SITE PLAN REVIEW

Wisconsin Stamping & Manufacturing / American Architectural Group

Village Planner Report

To: Jeffery W. Retzlaff, ACIP, Village Planner/Zoning Administrator
From: Eric Bartlein, Civil Engineer
CC: Larry Ratayczak, Director of Public Works; John Laning, Village Engineer
Date: April 5, 2017
Re: Wisconsin Stamping Proposed Addition Plan Review

Sheet Title:
LANDSCAPE PLAN

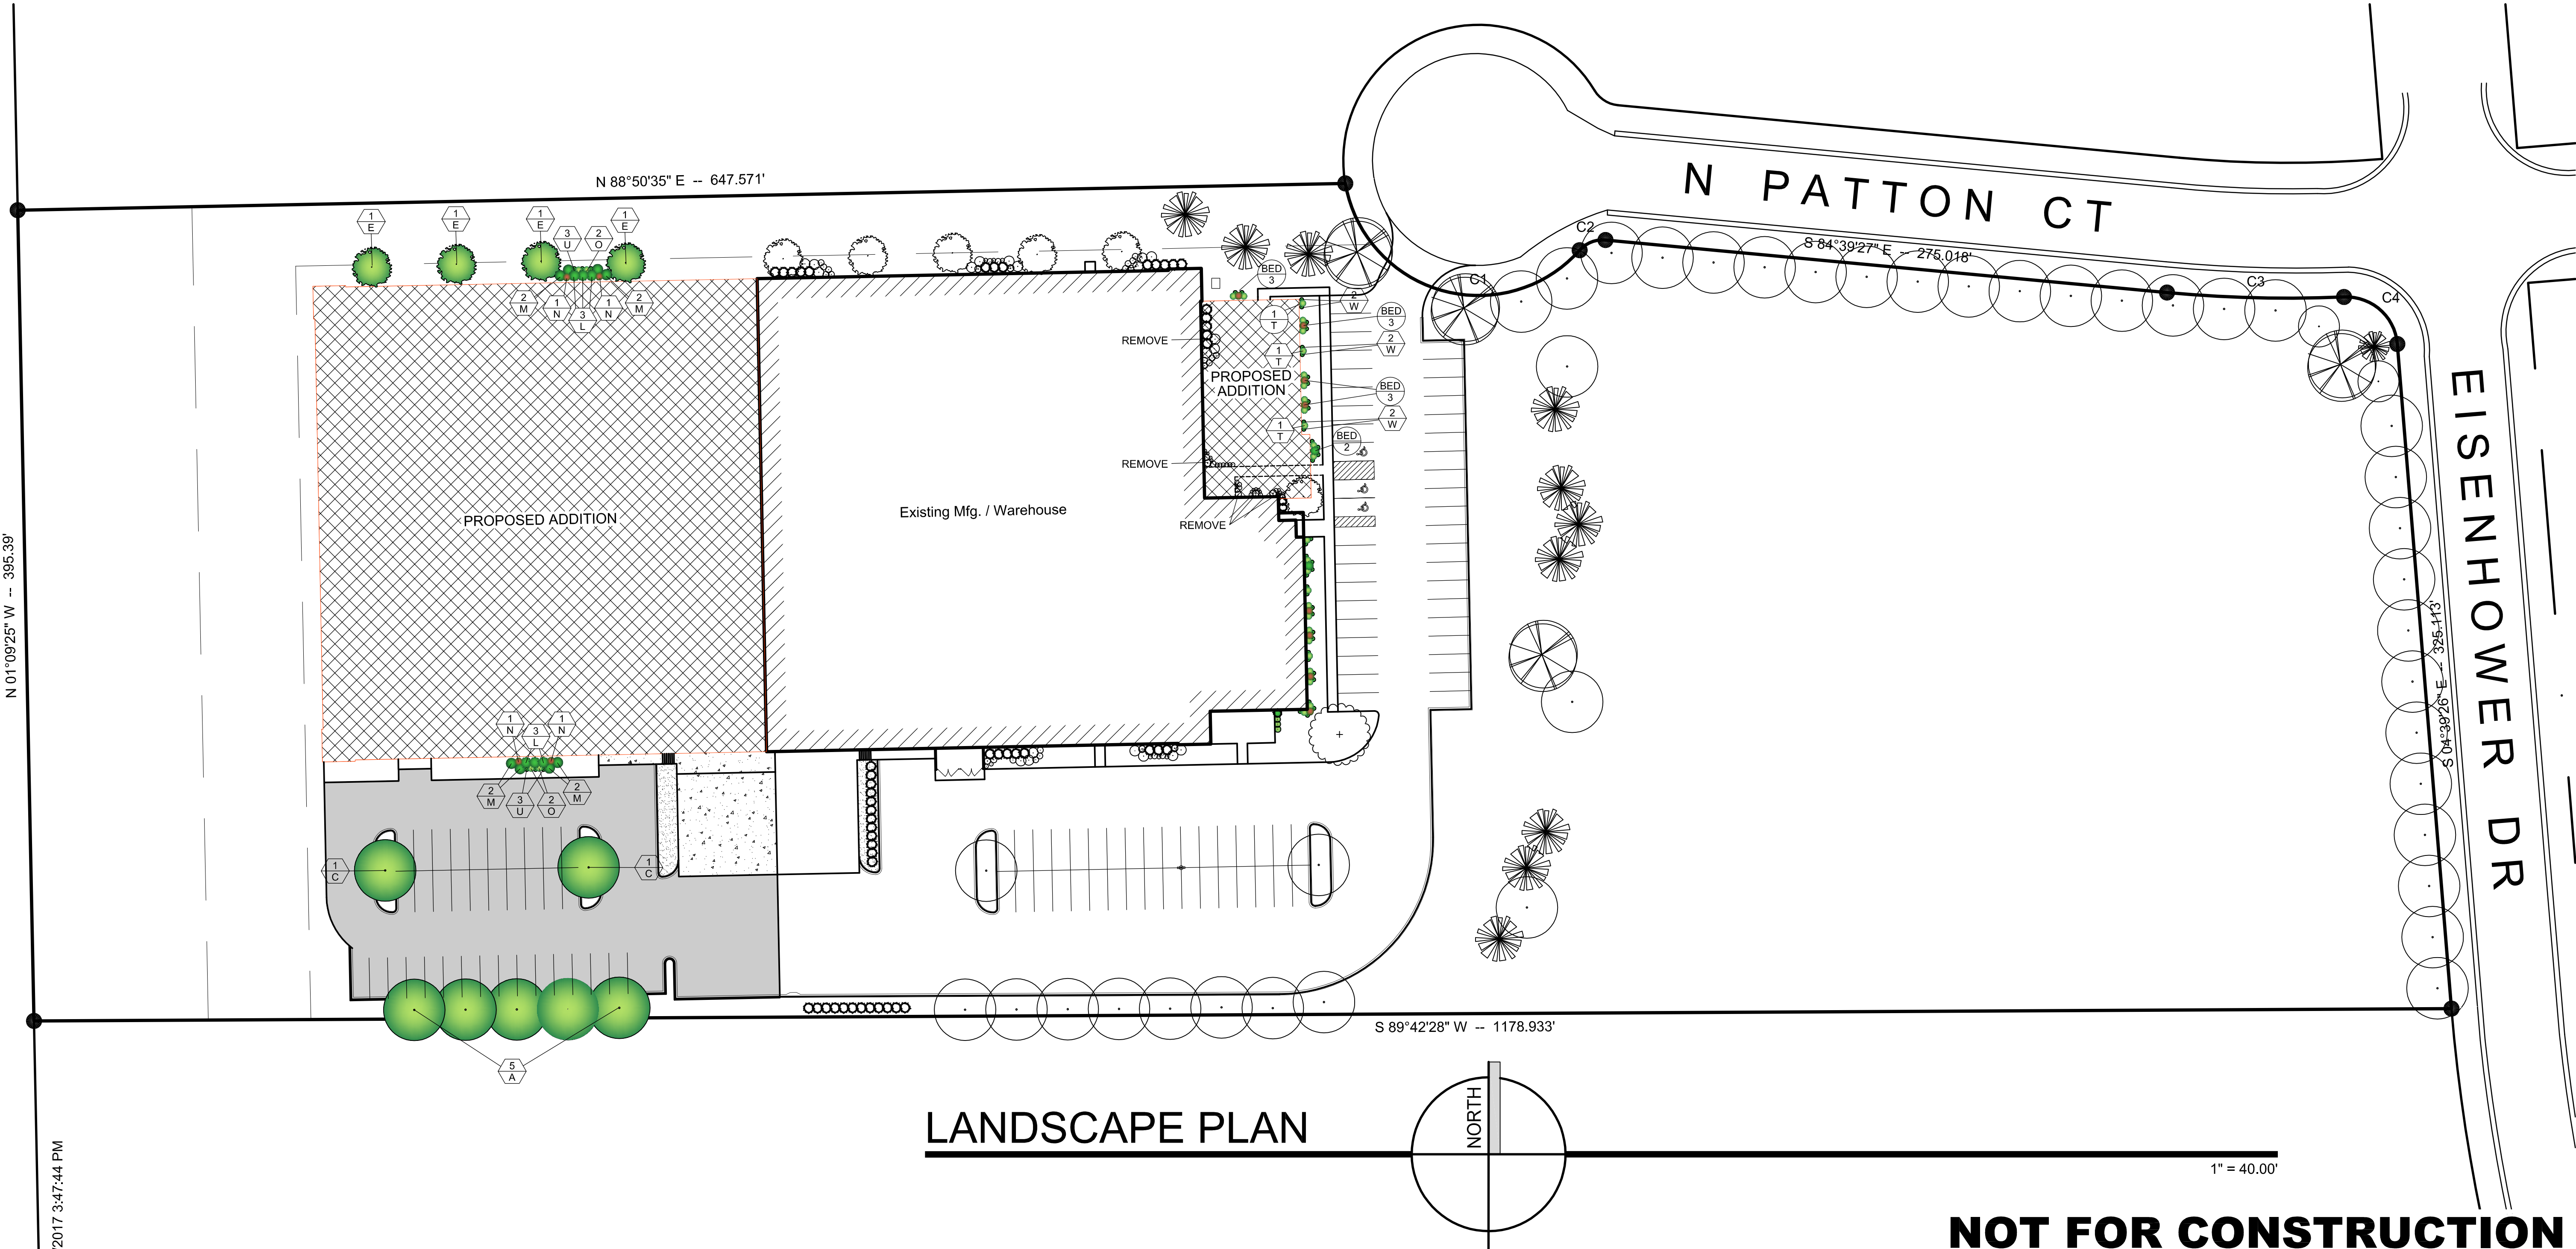
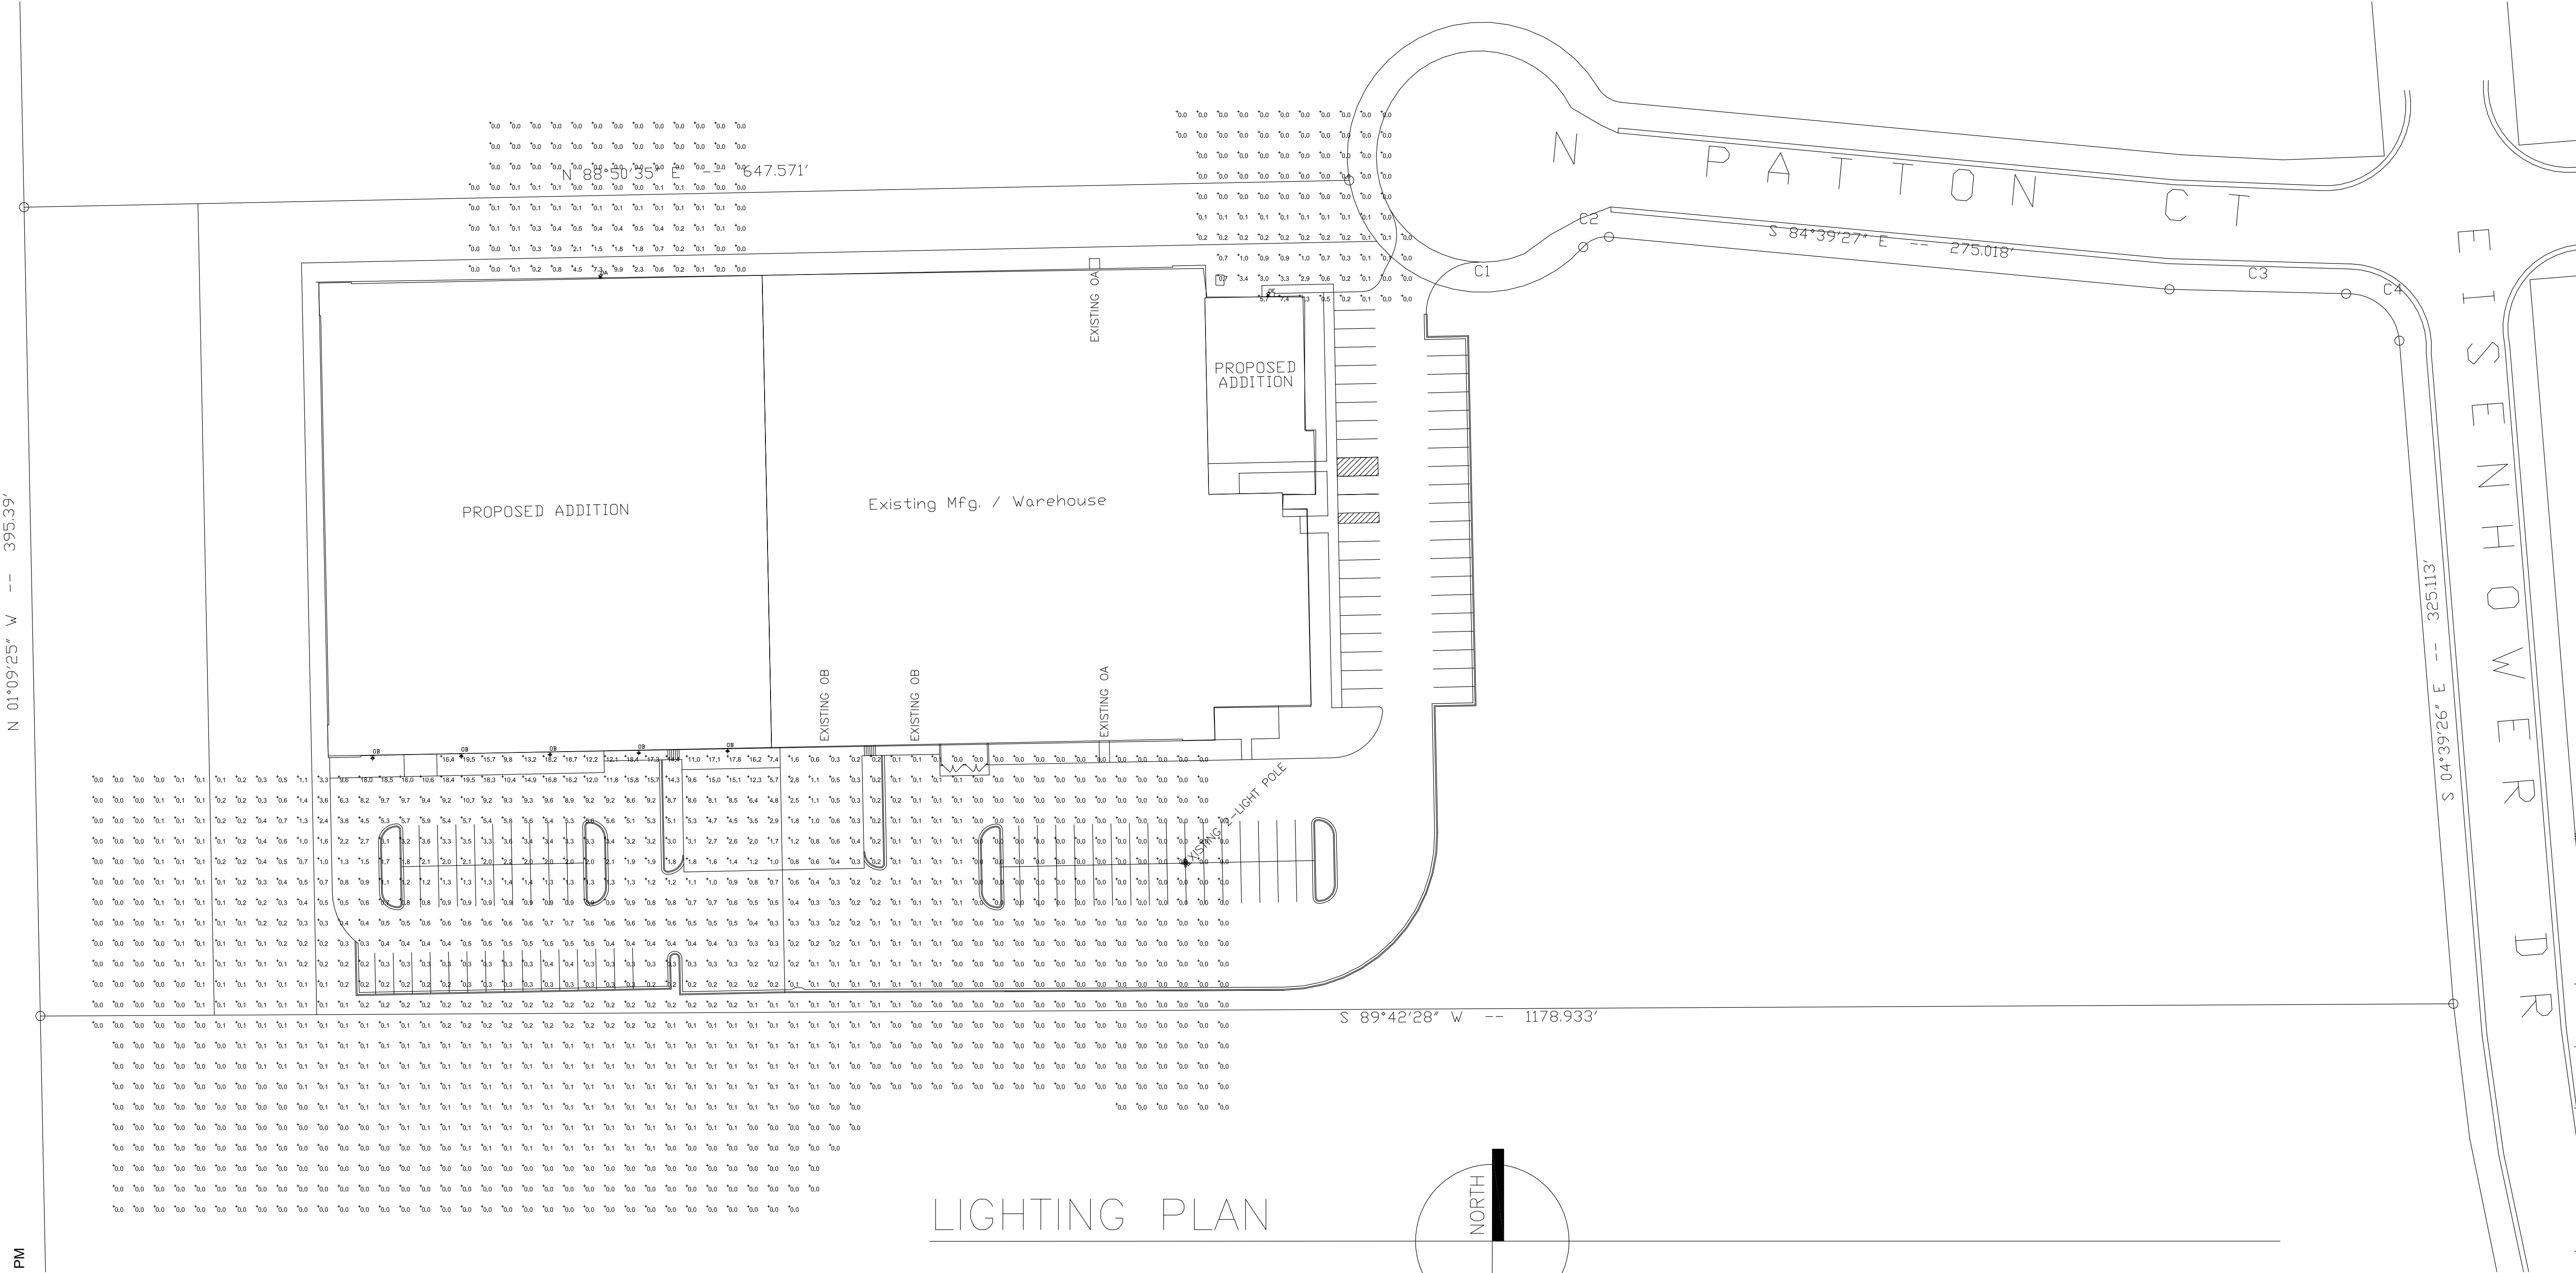
Landscape Plan – L-101

- No trees in the water main easement – Make sure the two Type C Trees in the medians will not be in the extended water main easement.
